AGENDA
FARRAGUT MUNICIPAL PLANNING COMMISSION

August 17, 2017
7:00 p.m. Farragut Town Hall

Thank you for your preliminary plat submittal for Phase 3 of the Bridgemore Subdivision. Below are the staff comments. Please address these comments and submit four (4) full size copies and one (1) 11" x 17" reduced set to the Farragut Town Hall by **Monday, August 7**. Also, upon resubmittal please include a letter which addresses these comments and that indicates where the information can be found on the plans.

Re: Comment Responses BridgeMore Preliminary Plat

DESIGNED BY	WCF	PROJ. MGR.	WCF	DATE
PROJECT	250.008	DATE	07/07/17	07/07/17
SHEET	C11	REVISIONS	NO.	DATE
SCALE	1"=50'	ISSUED FOR CONSTRUCTION		
		REVISOR/ISSUE

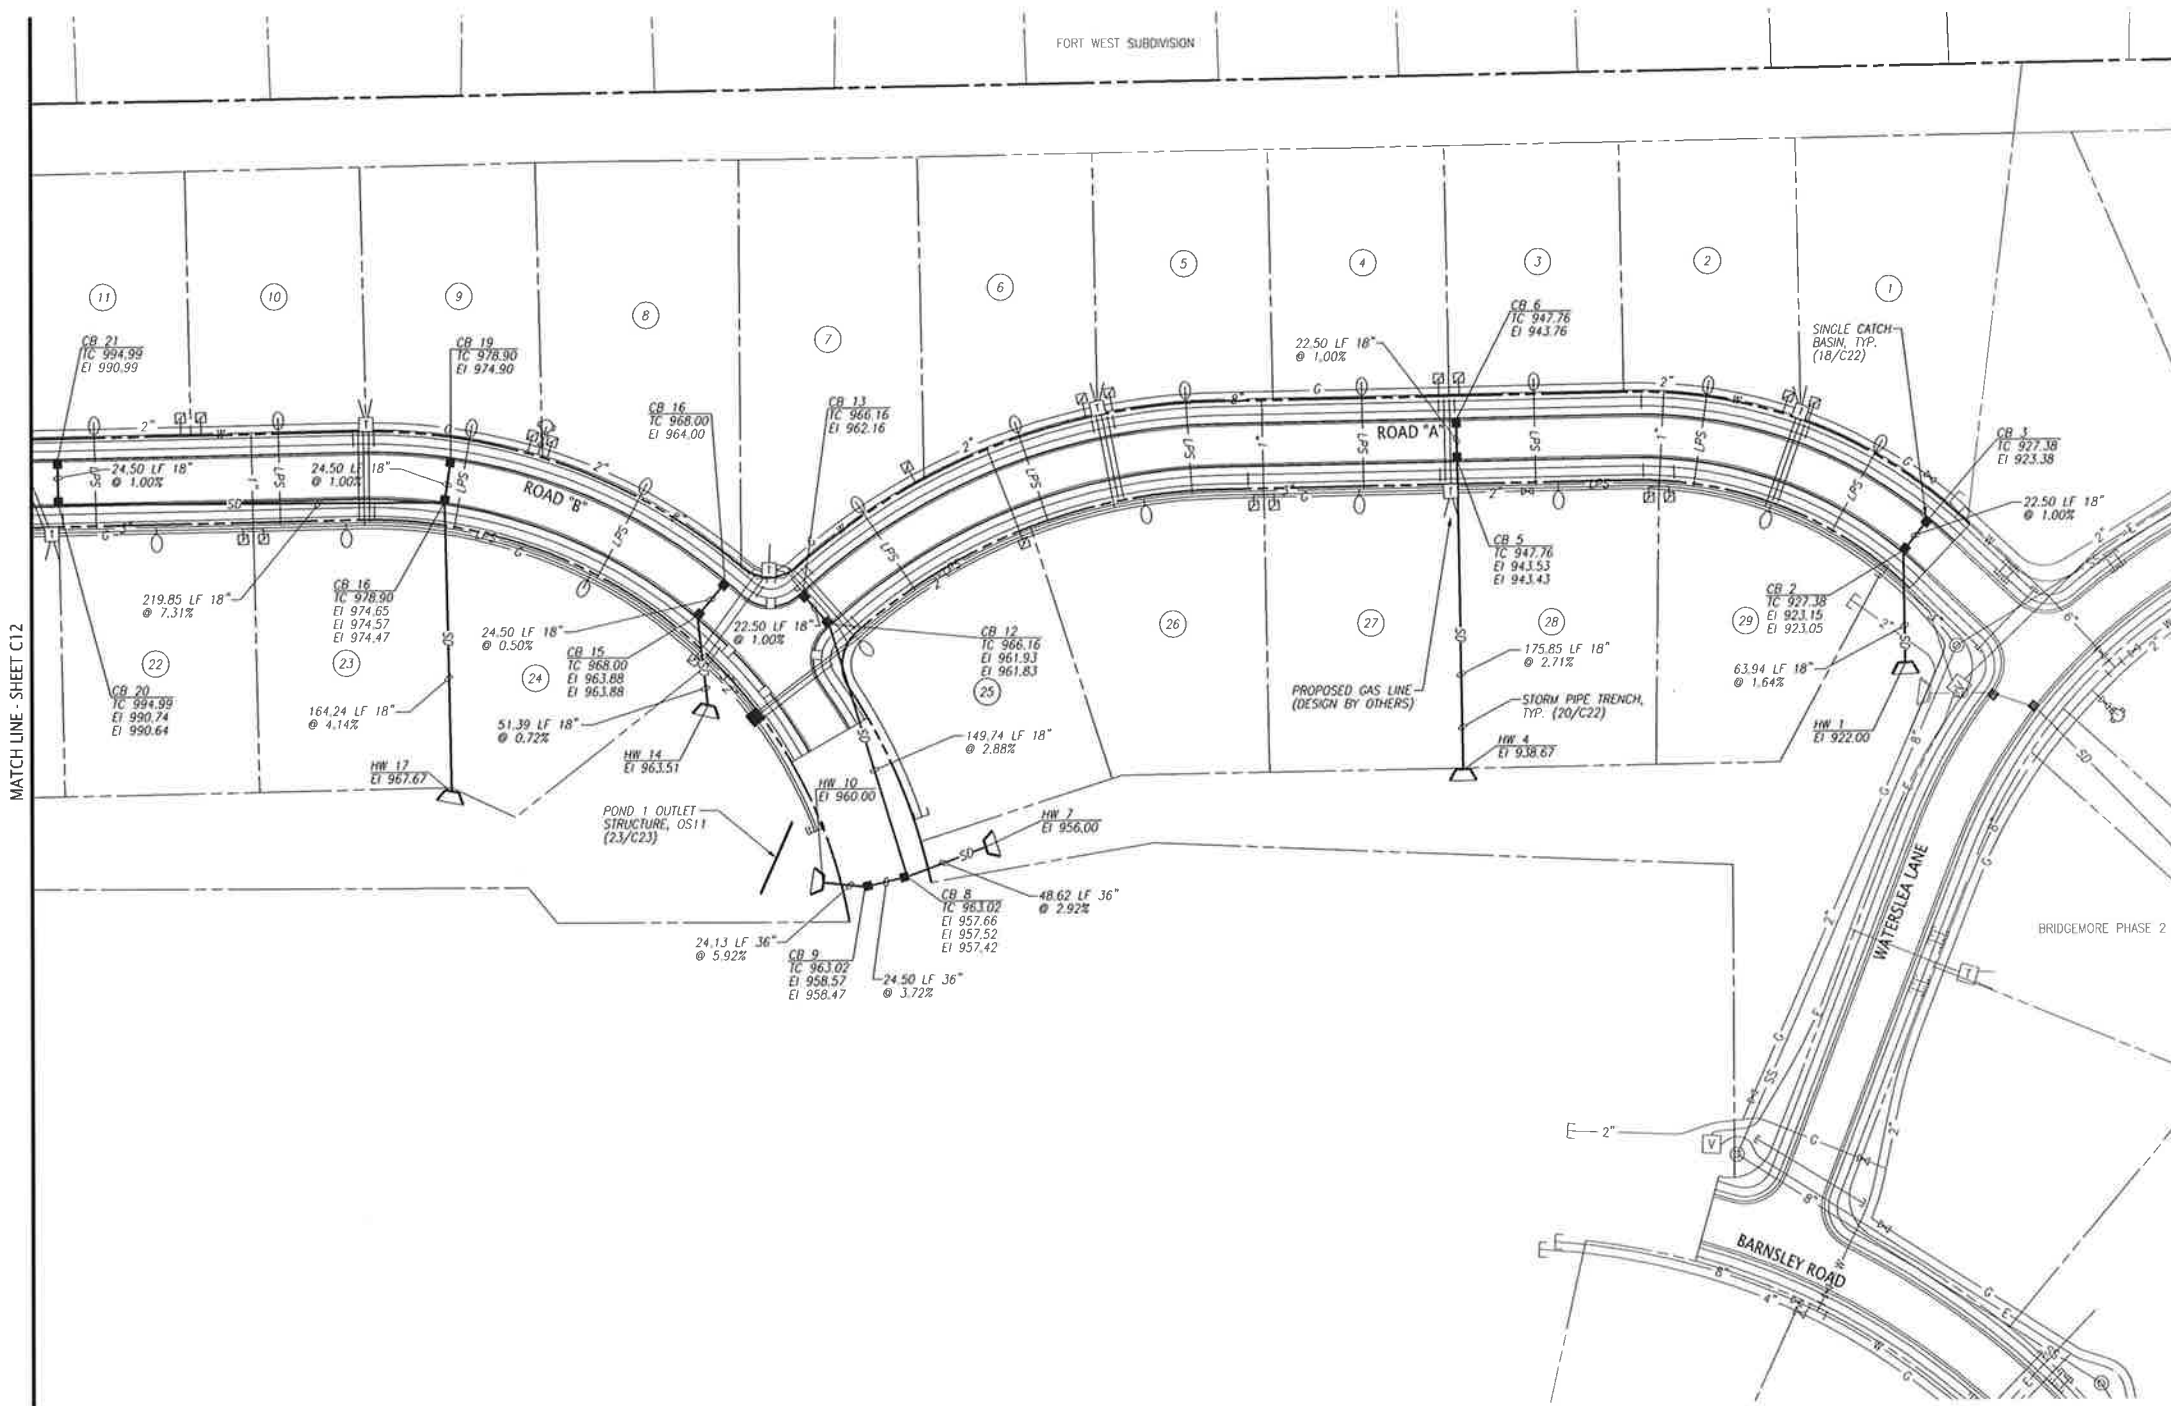
- 9) Please note the total drainage area;
- 10) Please provide detention basin details and include a summary table listing peak discharges for pre- and post-development and the differences in those discharges;

- 11) Please specify that the detention basin is designed for the 100 year-24-hour storm
- 12) Please provide a maintenance plan for each permanent SCM;

Response 9: Drainage areas, curve numbers, time of concentration calculations, etc. are included in the attached drainage calculations. This phase of work (Phase 3) falls within drainage areas SB12D-1, SB12D-2, and SB12B-1.

Response 11: Pond 1 corresponds to Pond 12-D2 in the drainage calculations. Pond 2 corresponds to Pond 12-D1 in the drainage calculations. Both ponds are designed for the 100-year, 24-hour storm; this information is stated in the attached drainage calculations.

1 TYPICAL 22' ROAD SECTION (25 MPH DESIGN SPEED)
C21 NTS

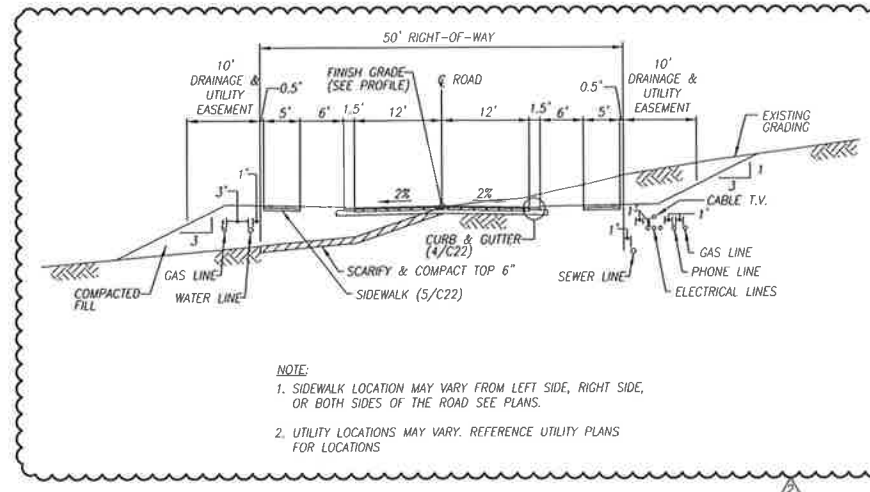
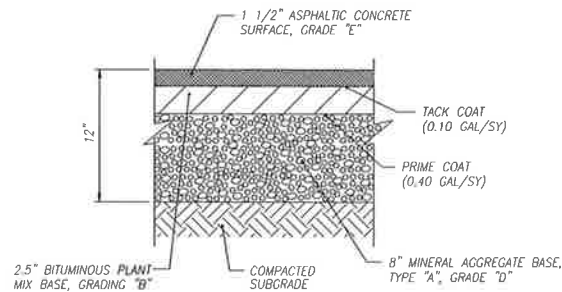
Comment 8: Please correct the road cross sections to show that sidewalks must be at least 5 feet in width. Also, in order to provide for the ability to add street trees, please increase the grass strip width from 3 to 6 feet. This would help avoid some problems that property owners are having with street trees damaging adjacent sidewalks;

Response 8: Details 1 and 2 on sheet C21 have been revised.

TITLE: SITE UTILITY PLAN	DRAWN BY: -	SHEET NO:
LOCATION: 820 N CAMPBELL STATION ROAD FARRAGUT, TENNESSEE 37932 CLT Map 130, Parcel Nos. 108 & 109	CHECKED BY: -	
	FILE NAME: 2086 - C7.0	
	JOB NUMBER: 2086	
Owner:

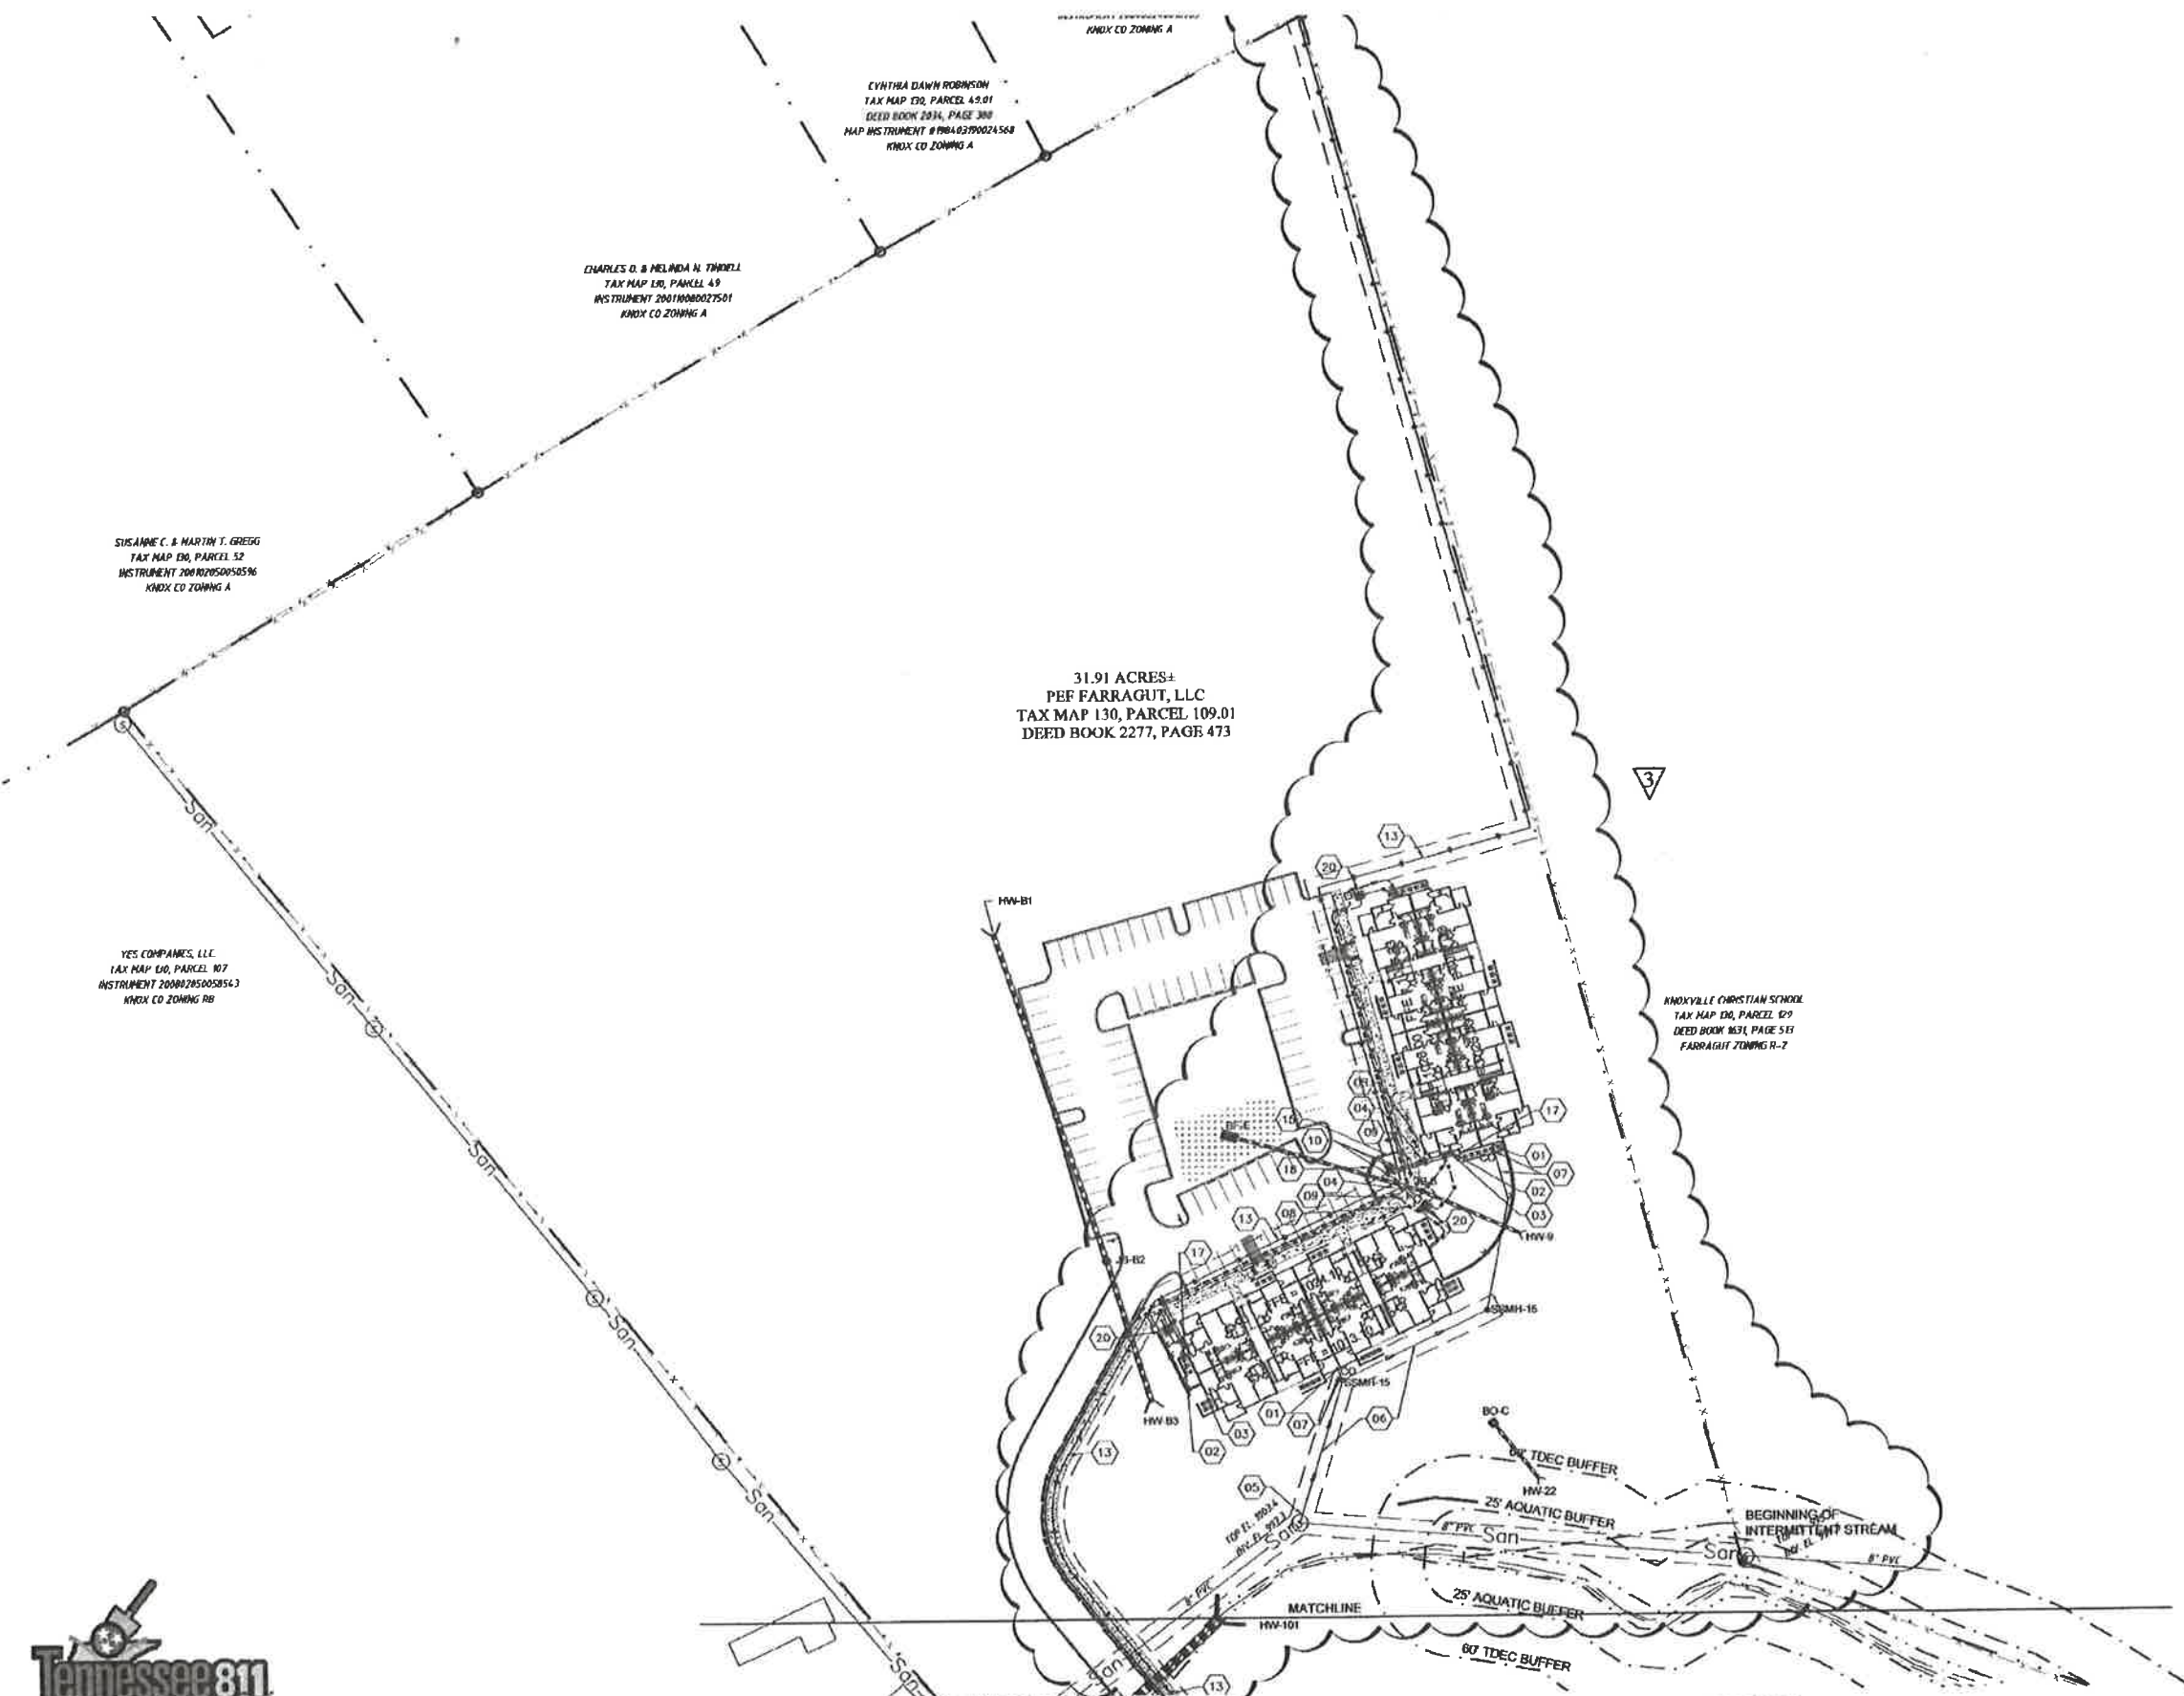
- 2) Provide a note on sheet C7.0 and C7.1 that ALL residential (R2) buildings will be protected with an NFPA 13 Fire Sprinkler System.
- 3) Several sheets, including C7.0 and C7.1, contain too many layers of information which make determining details difficult, if not impossible. Please turn non-pertinent layers off or provide separate sheets so that details may be confirmed.

- 4) Please incorporate the fire flow analysis summary data, as noted in the Cannon& Cannon document, into sheets C7.0 and C7.1. Additionally, provide the existing fire hydrant flow data points used to complete the analysis, on the drawings of record.
